Peer review of Horseshoe Bay Flood Study

Townsville City Council
A10416
007
00
3 May 2022

This peer review report documents the review findings for the **Horseshoe Bay Flood Study** prepared by AECOM under the Magnetic Island and Balgal Beach contract.

Figure 5.1 Topographic Changes at the Mouth of Endeavour Creek (left 2009 LiDAR, right, 2019 LiDAR)

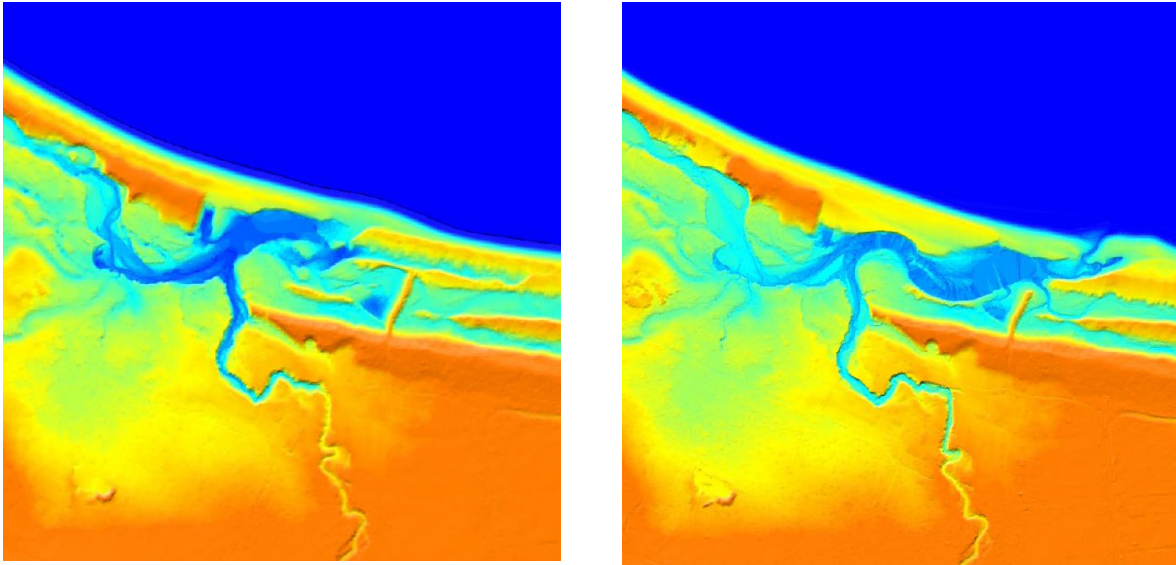
The date of the LiDAR capture used in the 2011 study is 2009. The LiDAR used in the updated AECOM modelling was captured in 2019. The 10 year difference in capture date will include differences in landforms as a result of development as well as natural catchment changes due to erosion and sedimentation processes (which may also be exacerbated by development). BMT has undertaken an independent comparison of the 2019 and 2009 LiDAR datasets and makes the following observations:

- As a general observation the 2019 LiDAR shows lower elevations across the modelled area.
- In the lagoon, the 2019 LiDAR is around 0.3m lower which likely reflects a change in water surface elevation between the two capture dates.
- The morphological condition of the estuary of Endeavour Creek is notably different between the 2019 and 2009 LiDAR datasets as shown in Figure 5.1 below. In 2019, the LiDAR shows an outlet through the dunes to the ocean, albeit highly constricted, whereas in 2009 there is a continuous sand bar across the entrance to the estuary. The LiDAR levels within the waterbody of the estuary are typically 0.1m to 0.3m higher in the 2019 LiDAR. This will likely reflect the water level at the time of capture. The increase in peak flood level in the Endeavour Creek estuary appears to be similar to the magnitude of the increase in LiDAR elevation.

In conclusion, based on a high level comparison it appears that the slight reduction in peak flood levels through the majority of urban areas outside of the influence of the tide are attributed to lower design rainfalls and the use of the ARR2019 ensemble approach to storm temporal patterns. The more notable differences (typically increases) in peak level within the lower parts of the catchment are attributed to the changes in estuary morphology and water level captured within the respective LiDAR datasets. This is despite the 2011 study using a higher tailwater (MHWS is stated as being 1.17mAHD in the 2011 study compared to 1.1m used in the AECOM study). Localised changes in peak flood levels may have also resulted from catchment development or drainage modifications.
